Re: 344.5 8th Street – Certificate of Occupancy

Please receive this request for obtainment of a Certificate of Occupancy for the project at 344.5 8th Street. The project is built in accordance with the Board Approved plans, as well as in conformance to the subsequently submitted revisions from April 2021. Following our discussion on January 17, 2022, please see below some deviations for which we are seeking Administrative Approval. I've included a description of all items reference in an email from you on 12/22/21, with explanations to each minor deviation for your record. I would greatly appreciate a prompt review of this request for a final Certificate of Occupancy:

1. Part Elevation from approved HPC set illustrating proposed Cornice

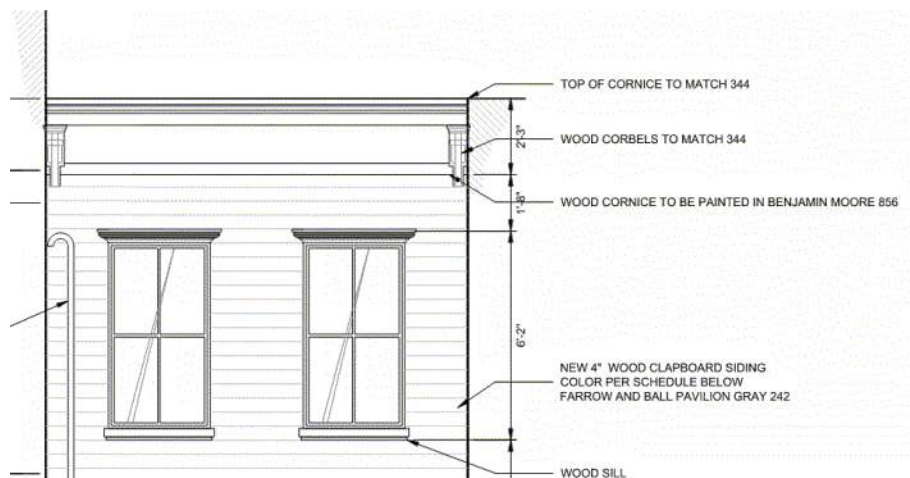
- 1) The front cornice has been installed as per the approved drawings sheet numbers #A200, and A500.

2. Front Elevation showing reconstructed Cornice to match approved drawings

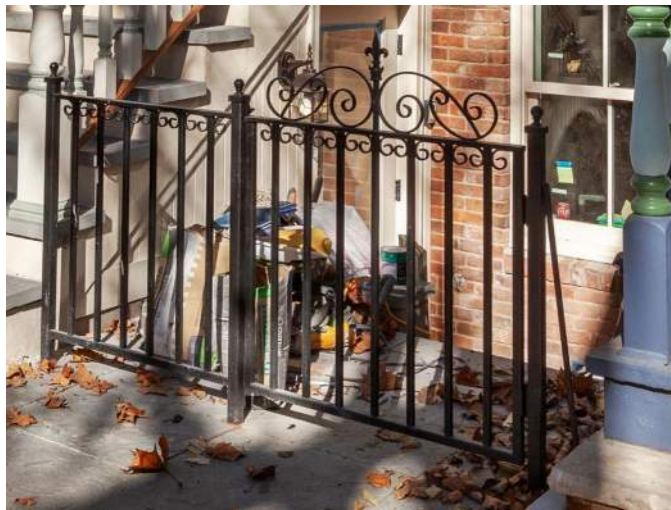
- 2) We request Administrative Approval to have the color of the cornice modified to Historic Colors by Benjamin Moore HC-54, and HC-141 as illustrated on the front photograph in the preceding page.
- 3) We request Administrative Approval that the electrical service line be installed in the same location that it was placed in prior to the renovation. The existing tree directly in front of the western side of the House, preventing installation by PSEG of the incoming service on the west side.
